SUNSET VILLAGE FILING NO. 4

CONSTRUCTION PLANS

MODIFIED FOR S.I.A. CD SET
 RICHARD D. LYON, PE
 ATWELL, LLC.
 DECEMBER, 2021
 EPC PROJ.: CDR-21-008

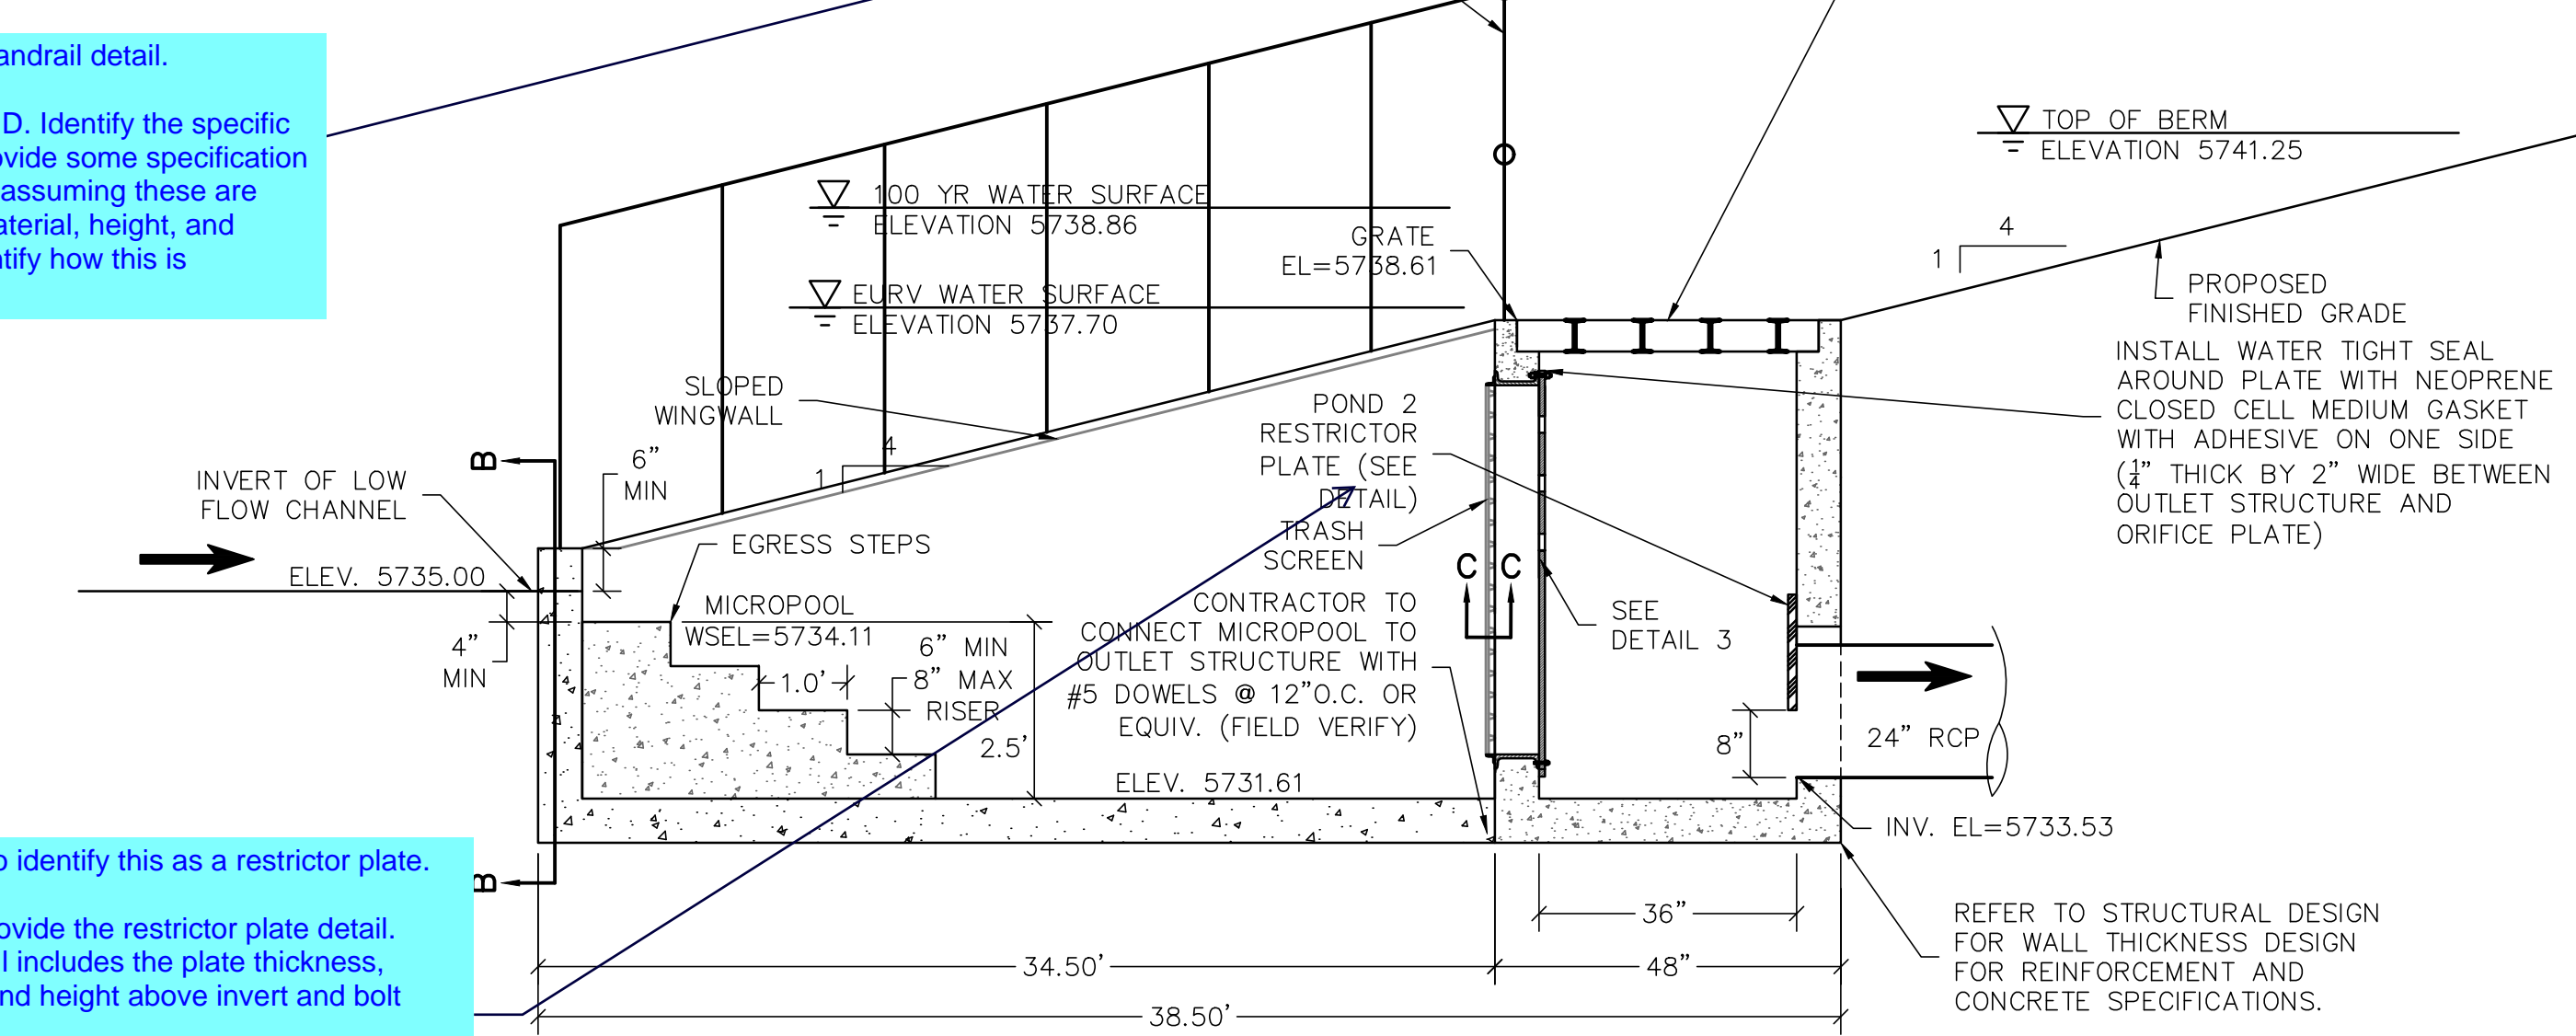
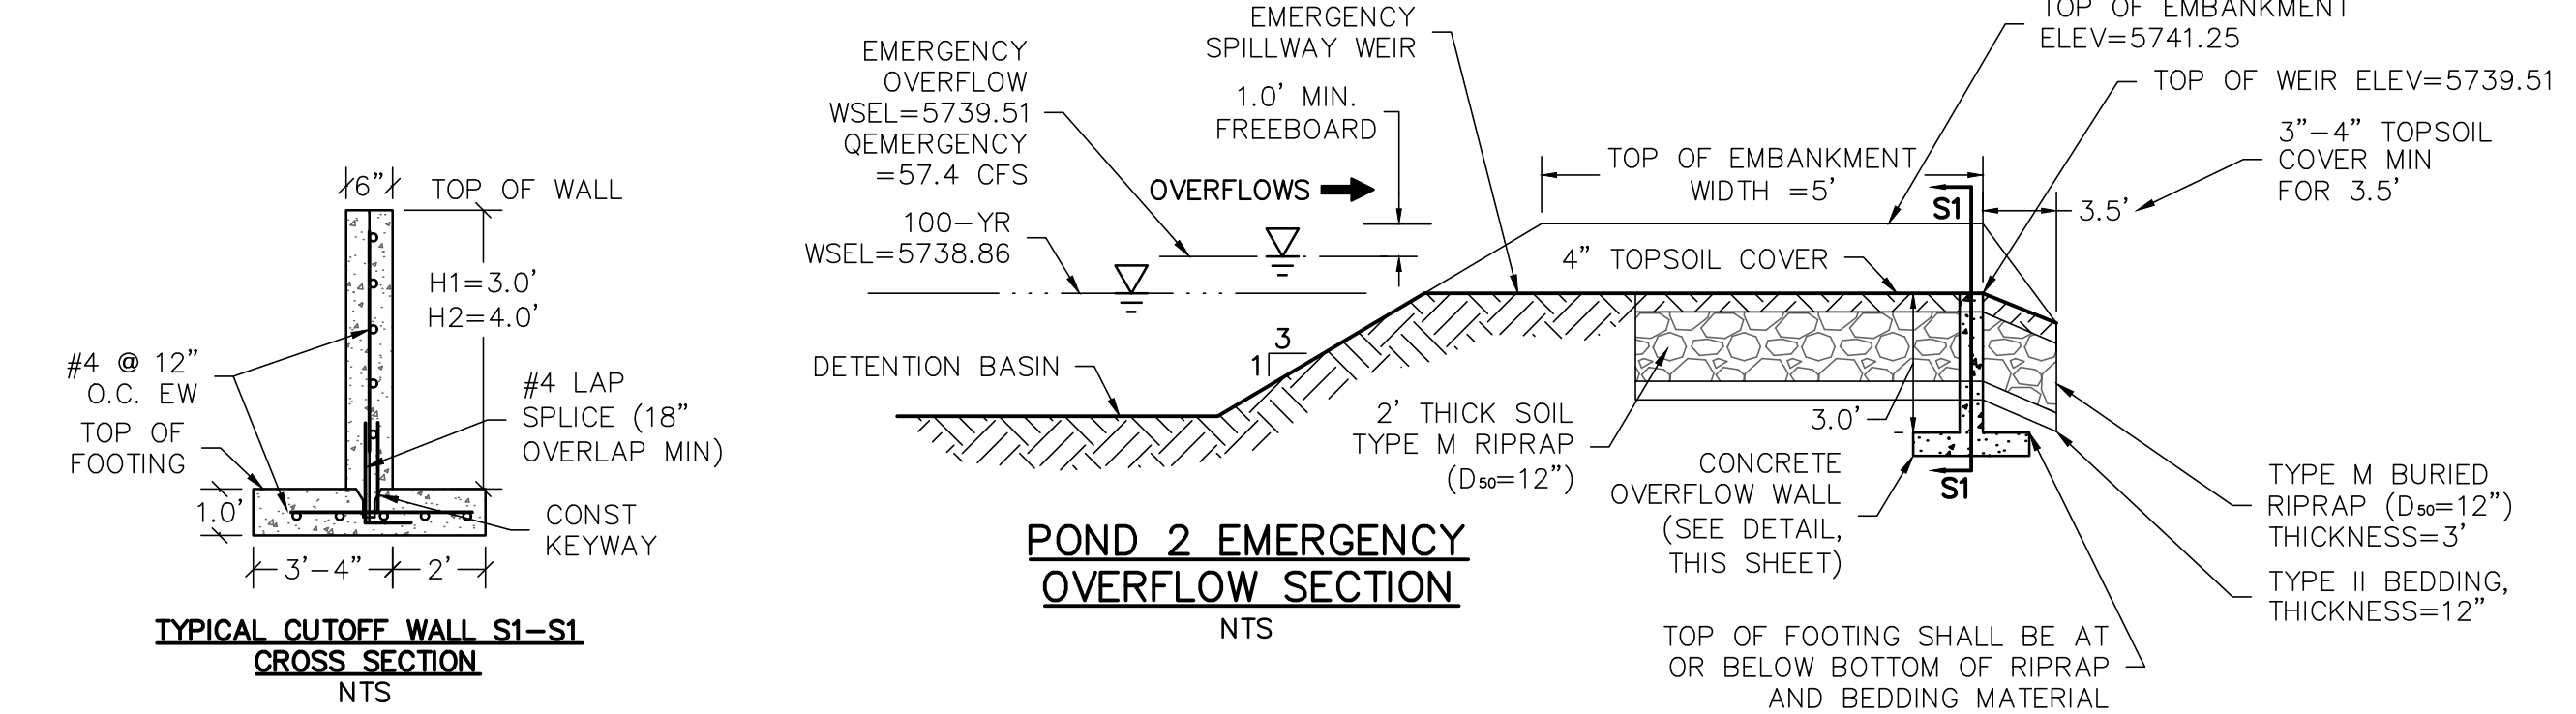
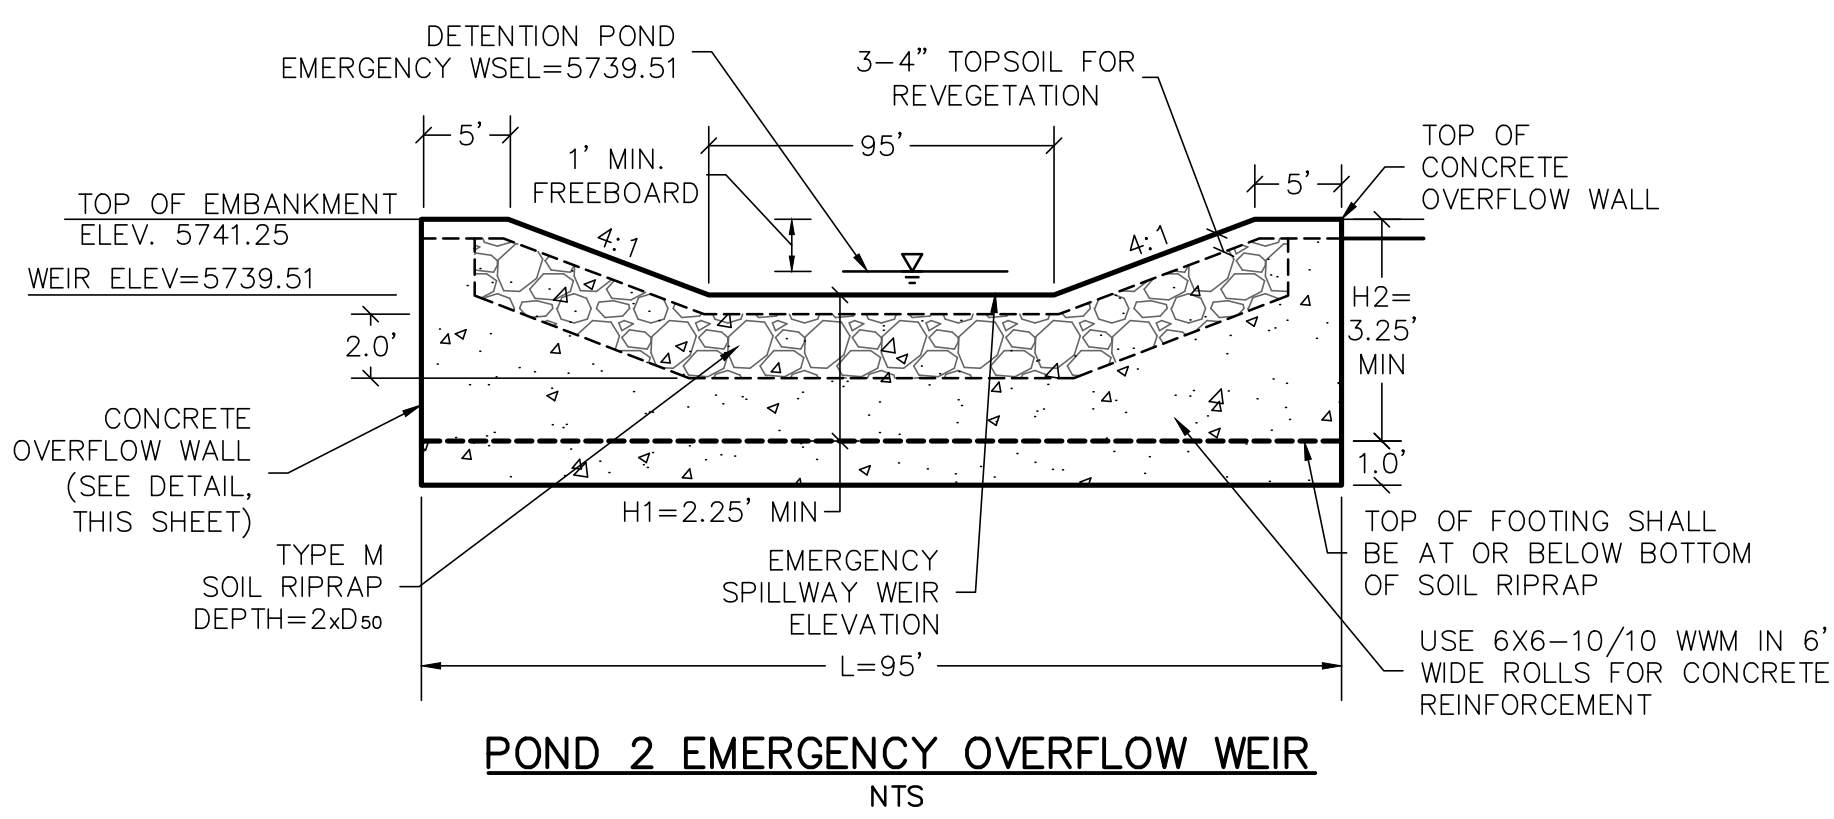
Provide the handrail detail.
UNRESOLVED. Identify the specific product or provide some specification such as size (assuming these are tubes) and material, height, and spacing. Identify how this is connected.

Revise callout to identify this as a restrictor plate.
[Unresolved] Provide the restrictor plate detail. Make sure detail includes the plate thickness, length, width and height above invert and bolt spacing.
